**LETTER OF TRANSMITTAL**

Date: August 5, 2019  
 Site Name: Former Biogenesis  
 Address: 610 W. Rawson Ave.  
Oak Creek, WI  
 FID# 241020010  
 BRRTS # 02-41-107191 & 06-41-582006

RE: Post-Remediation Groundwater Monitoring Plan Addendum  
Former Biogenesis  
610 W Rawson Ave  
Oak Creek, WI  
FID No. 241020010  
BRRTS No. 02-41-107191 & 06-41-582006

**Figure 1**

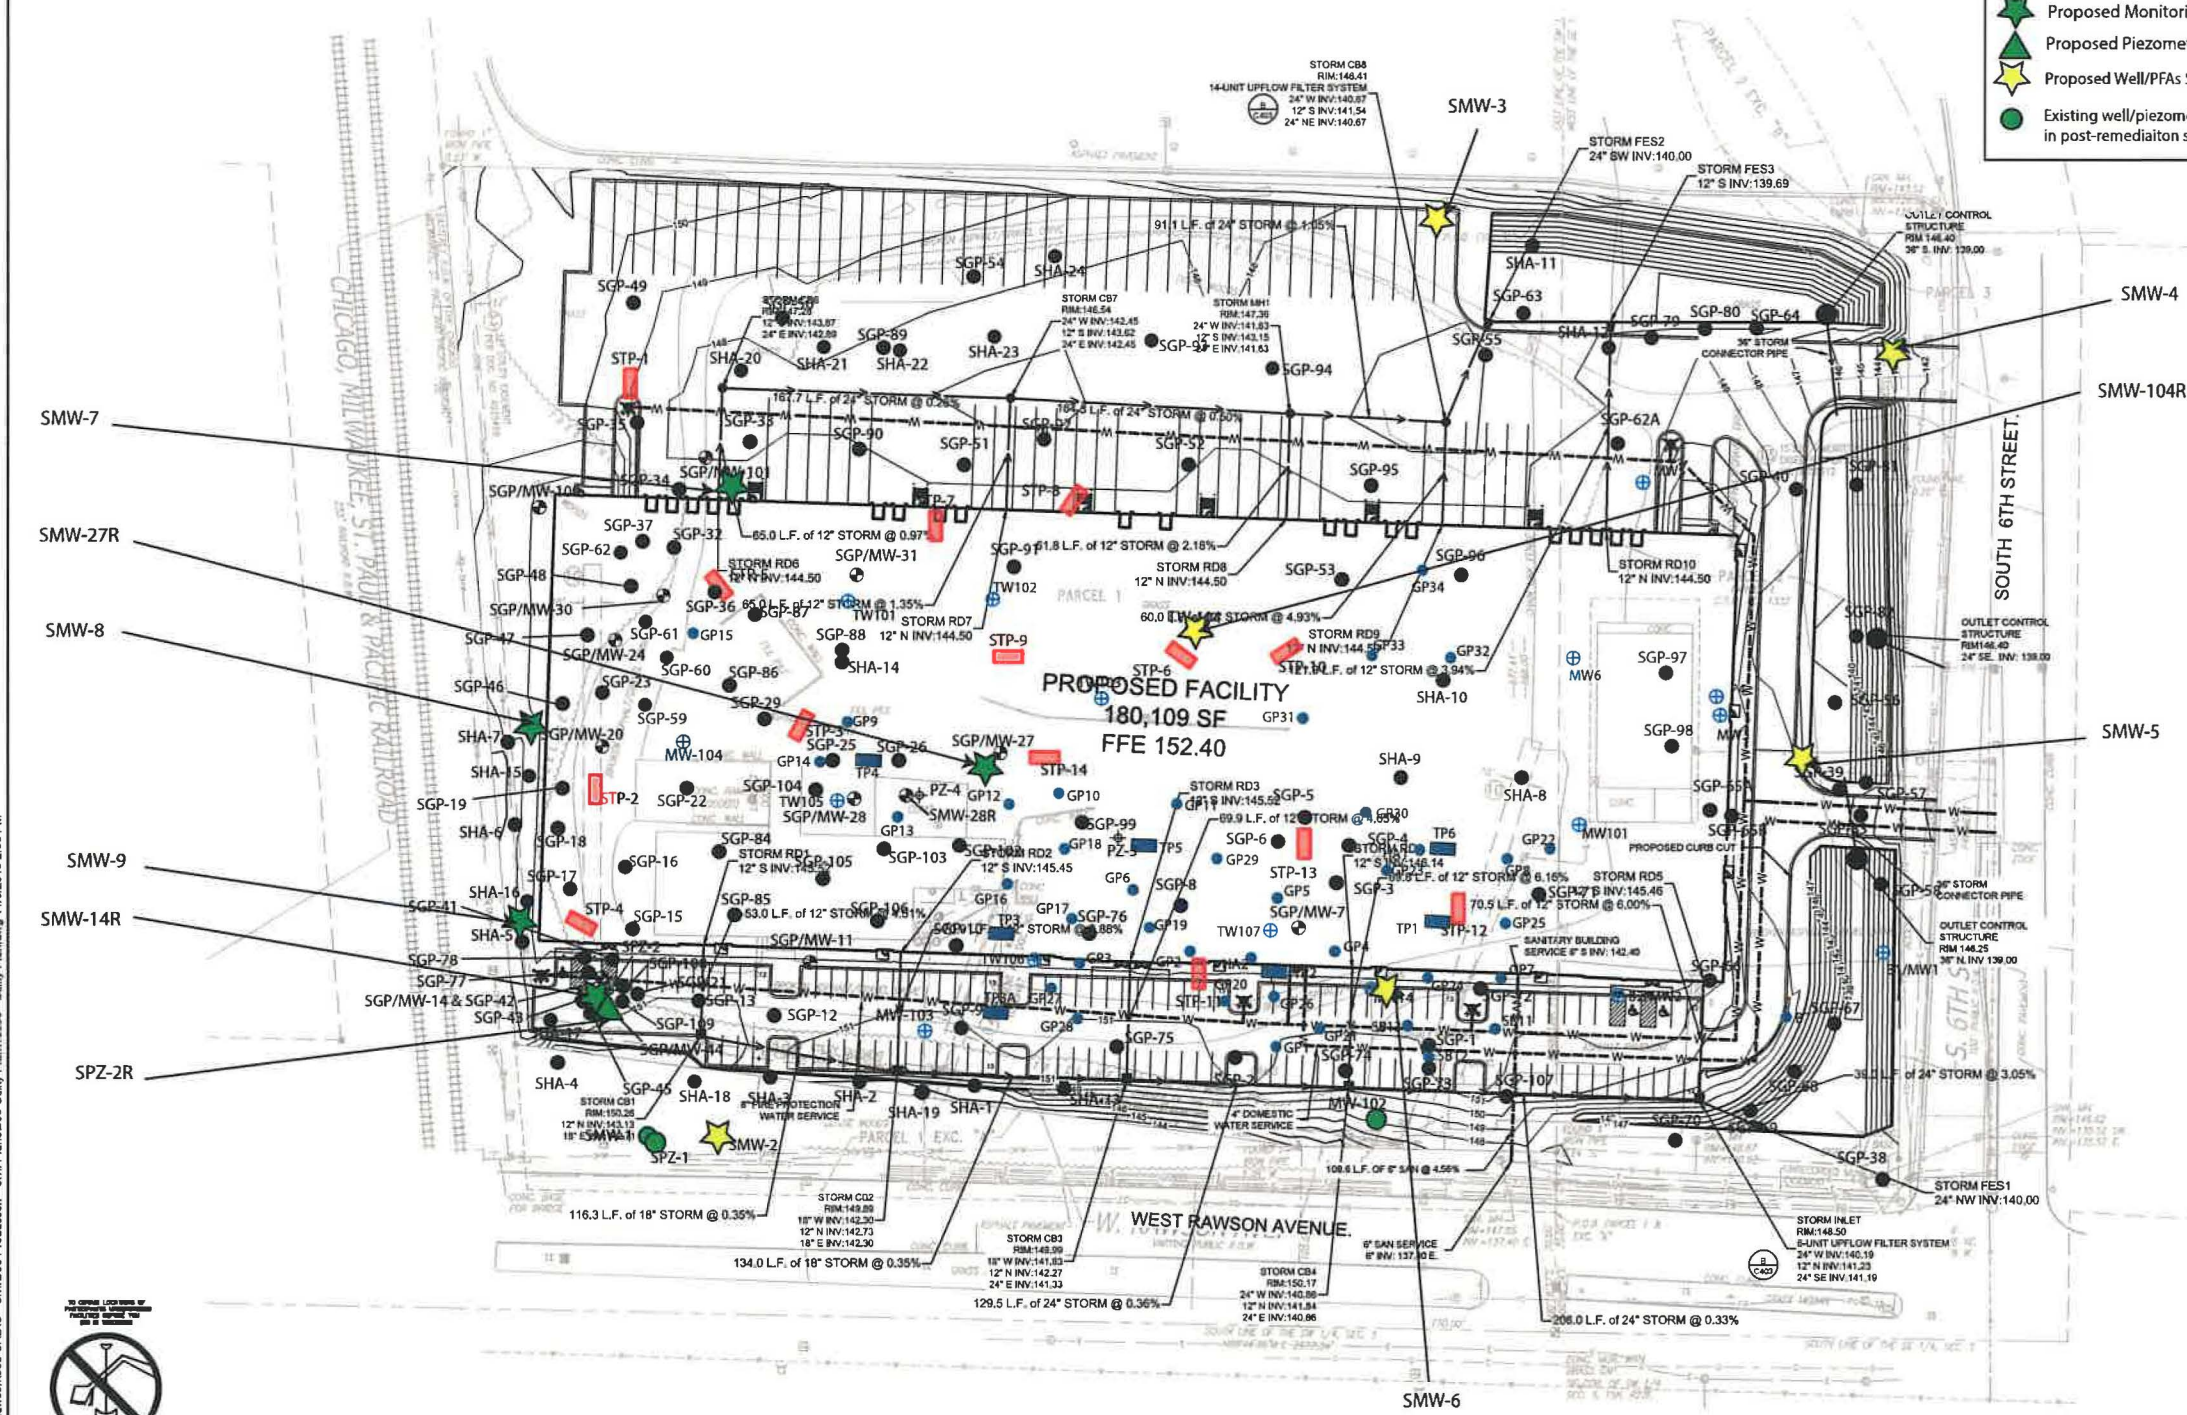
Based on comments received at our meeting on July 29, 2019, Sigma has updated the recommended locations for select replacement/additional groundwater monitoring wells. A map illustrating the updated proposed locations is included as **Figure 1**.

- The replacement monitoring well formerly proposed to be located near former well SGP/MW-11 is relocated adjacent to SGP/MW-27 (inside the proposed building footprint). Shallow groundwater impacts were not identified in samples previously collected from MW-11; therefore, the location for the replacement monitoring well will be shifted to near former well MW-27 where shallow groundwater impacts had been previously identified.
- An additional well location is proposed to be located at the location of former well TW-104/TW-104R (inside the proposed building footprint). Although it was previously determined that a replacement monitoring well would be required within the building footprint, a specific location for the well within the building footprint had not been specified to date.

- The proposed location for the additional monitoring well to be located north of the new building near the northern property boundary is shifted further to the east. Based on available shallow groundwater measurements, a location further to the east is more likely to be down-gradient from the location of former wells TW-104 and TW-104R, where previously collected samples have identified the presence of per- and polyfluoroalkyl substances (PFAs).

- a replacement well and piezometer are proposed near the southwest site corner in the area of former well MW-14 and SPZ-2;
- replacement monitoring wells are proposed to the west of the new site building in an area where VOCs had been identified within shallow groundwater during site investigation activities;
- a replacement monitoring well is proposed to the north of the new site building in the area of former well MW-101 (a location determine to be down-gradient from the west-central part of the site based on pre-remedial investigation activities);
- a replacement monitoring well is proposed for the former Northern Environmental MW-14 location where shallow groundwater impacts had been identified; and
- remaining proposed well locations are near the down-gradient property boundaries.

Sampling for PFAs: 6 proposed replacement/additional monitoring wells labeled in yellow as illustrated on attached **Figure 1**, (SMW-2, SMW-3, SMW-4, SMW-5, SMW-6 and SMW-104R).
